Waterbury Filing Nos. 1 and 2
Traffic Impact Analysis
(LSC #204220)
February 12, 2021

LSC Response to TIS Redlines June 2021

Figure 7

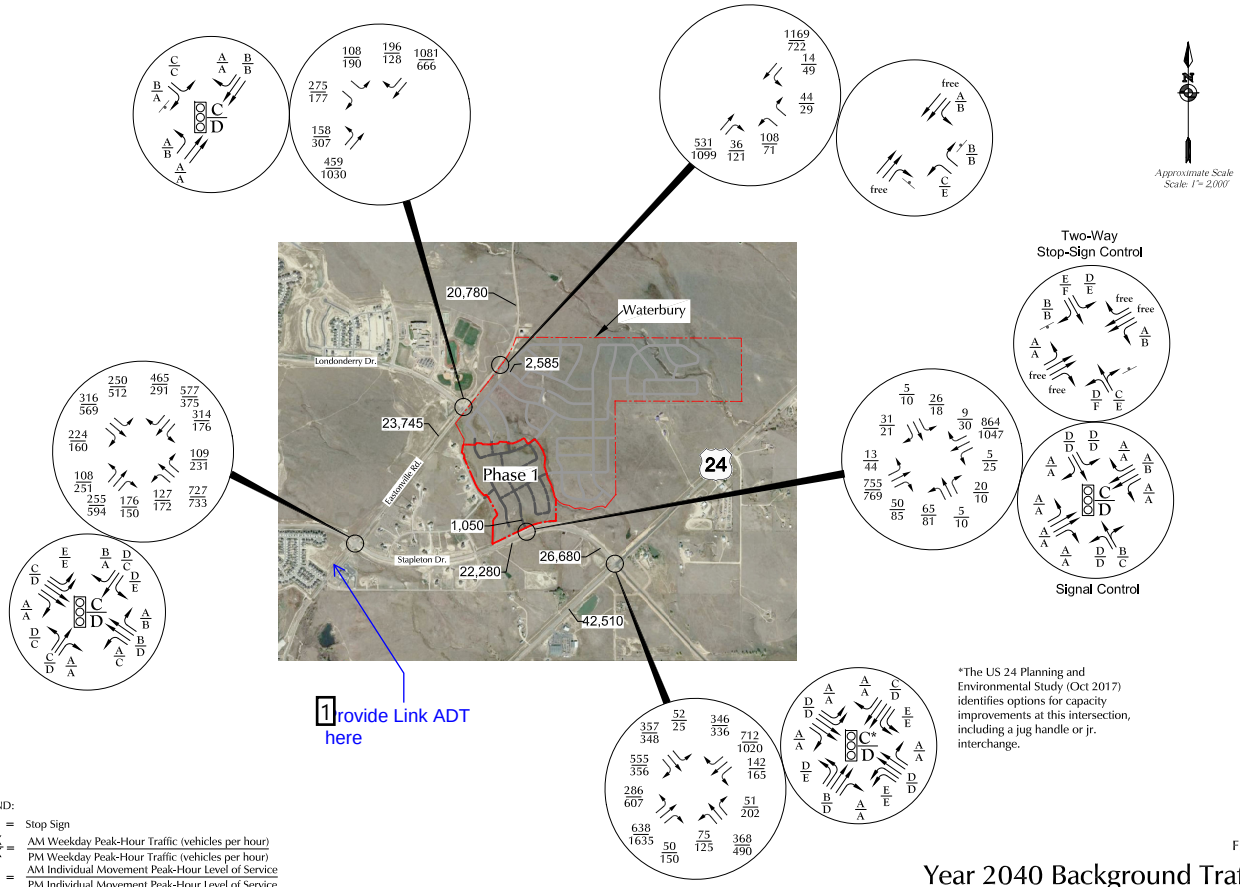
Provide Link ADT here

LSC Response: The additional information has been added as requested.

Figure 9

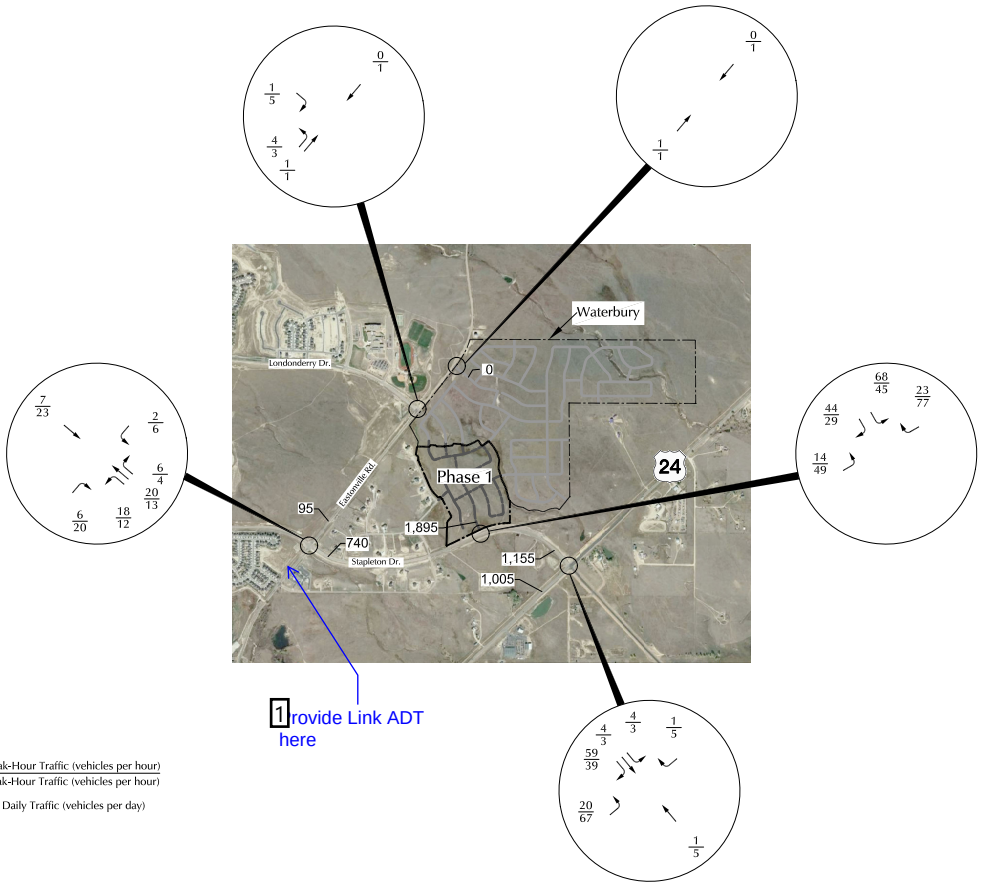
Provide Link ADT here

LSC Response: The additional information has been added as requested.

Figure 10

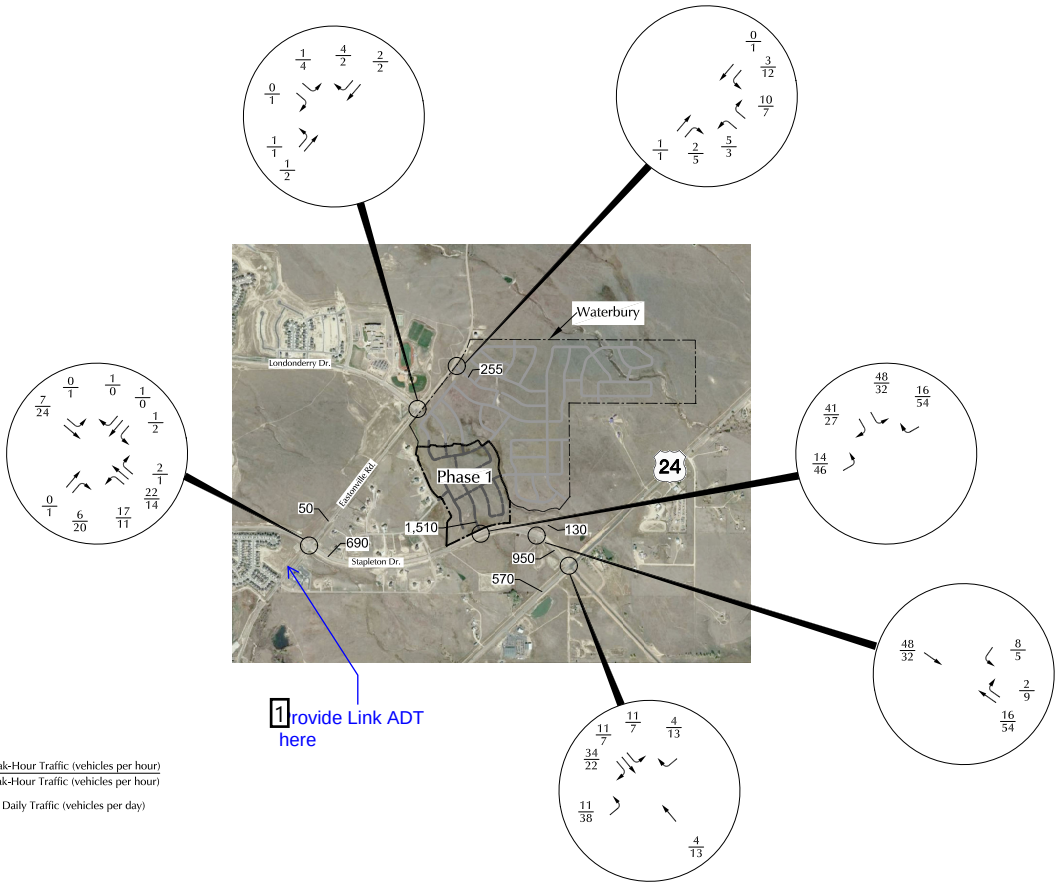
Provide Link ADT here

LSC Response: The additional information has been added as requested.

Figure 11

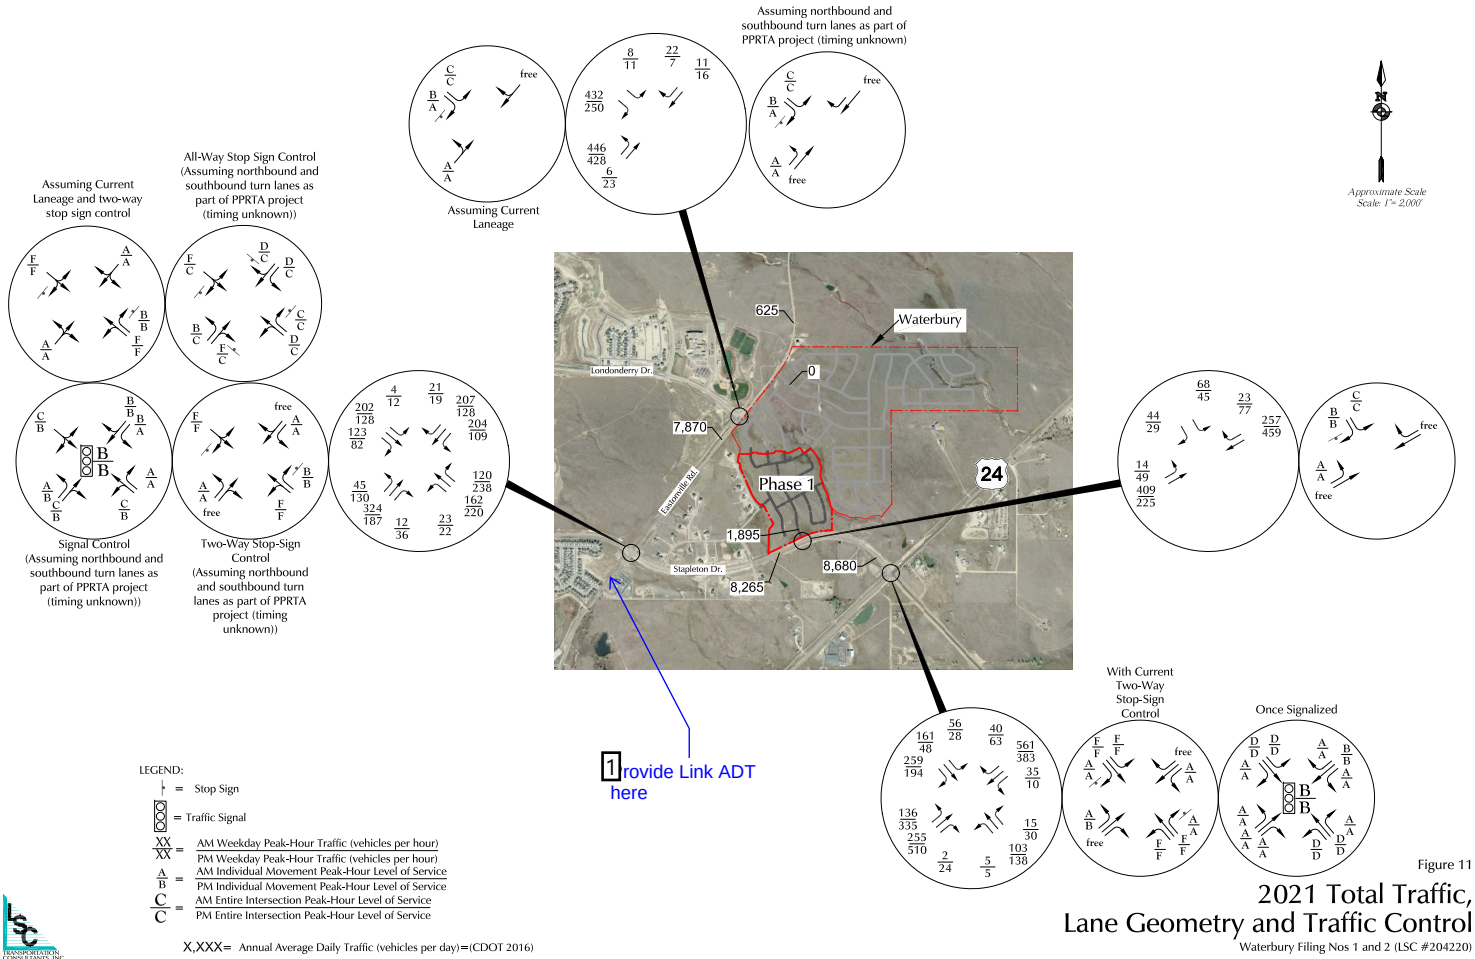
Provide Link ADT here

LSC Response: The additional information has been added as requested.

Figure 12

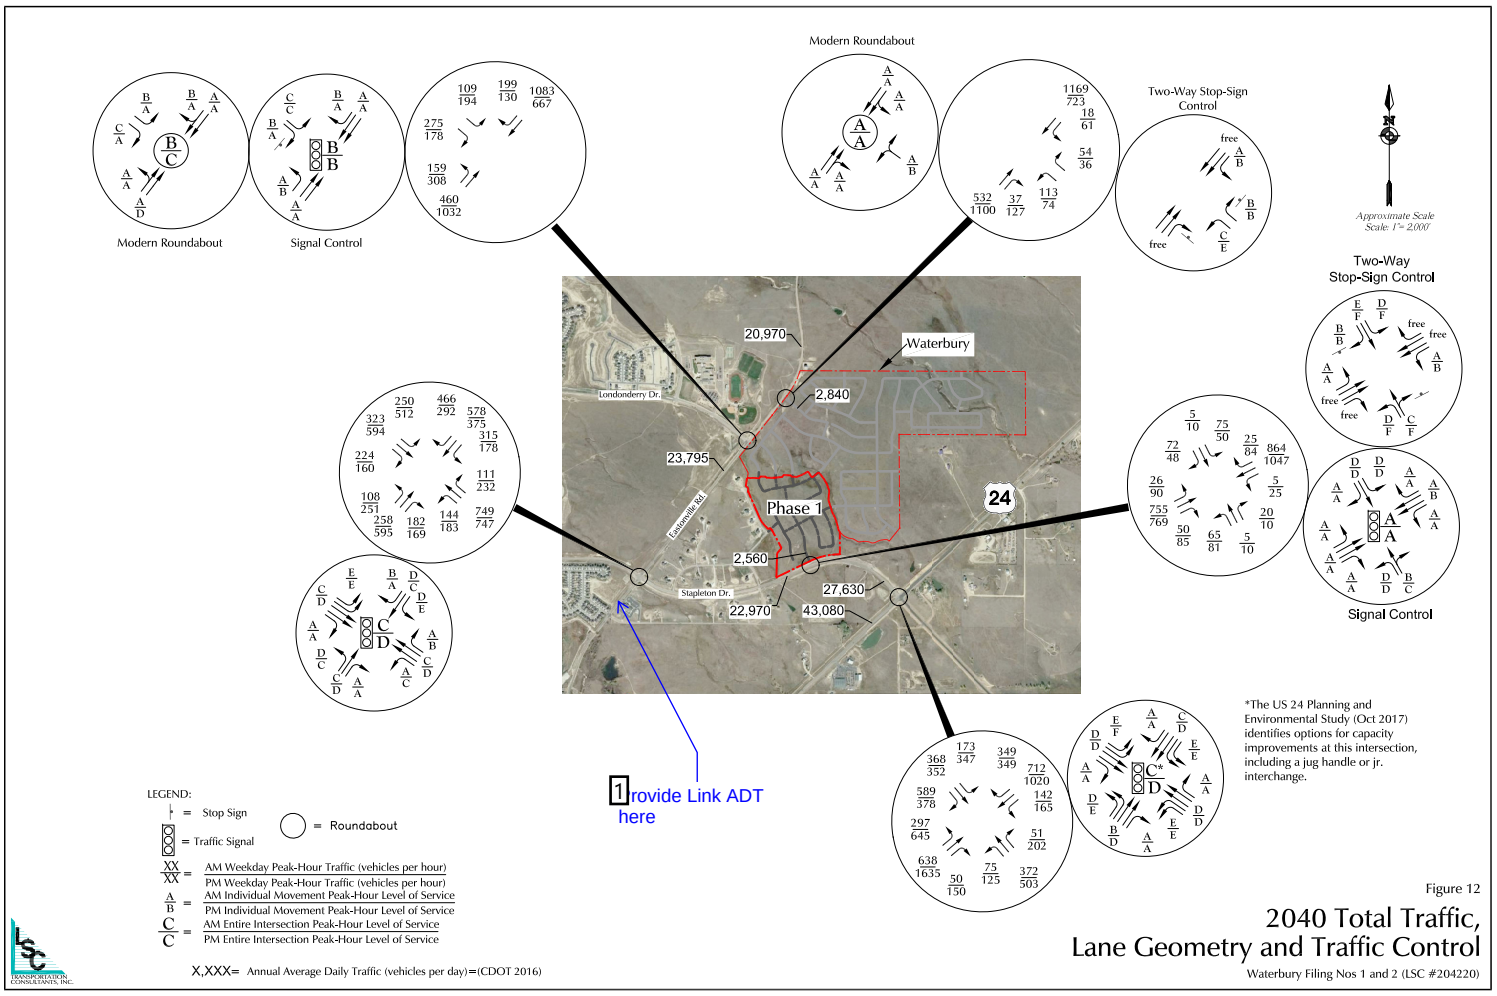
Provide Link ADT here

LSC Response: The additional information has been added as requested.

Figure 13

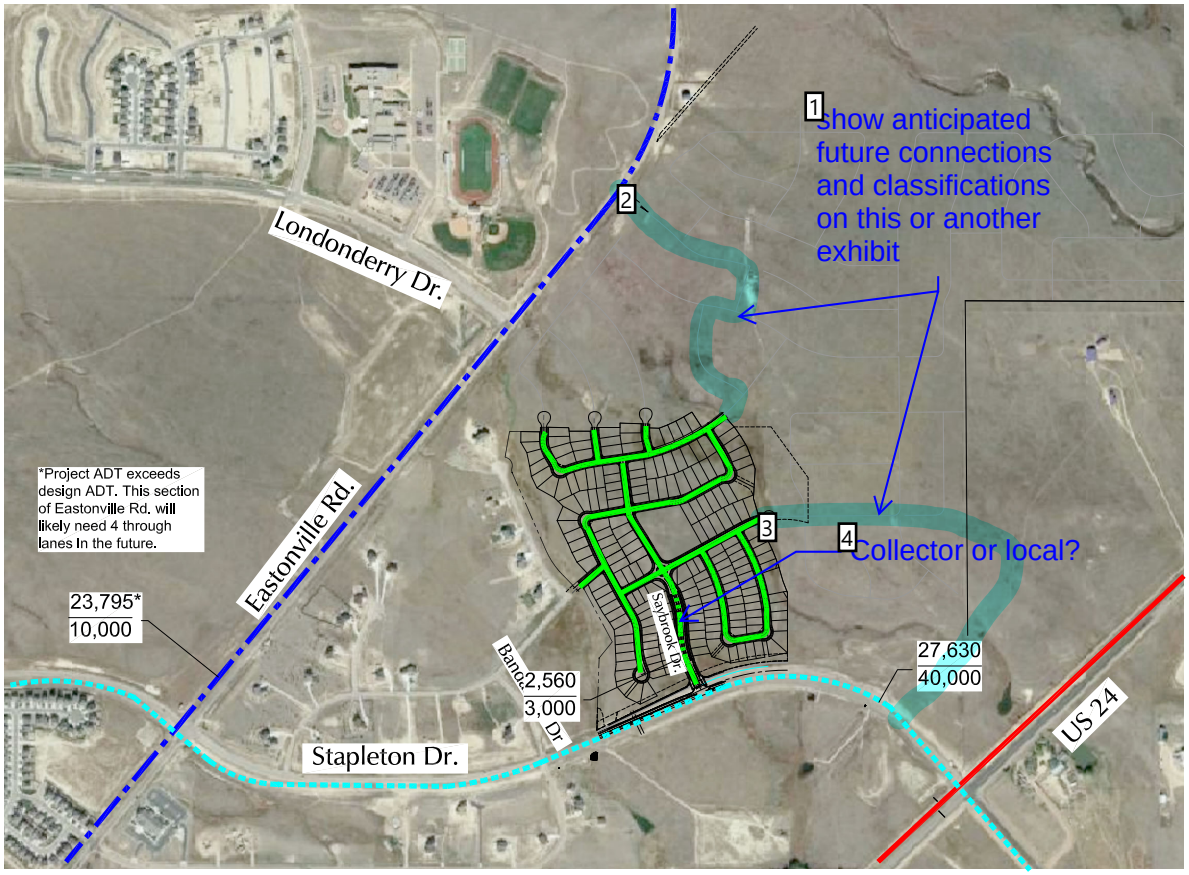
show anticipated future connections and classifications on this or another exhibit

Collector or local?

LSC Response: The additional information has been added as requested.

LSC Response: The figure has been revised to make it more clear that the recommended classification for Saybrook Road is Urban Residential Collector.
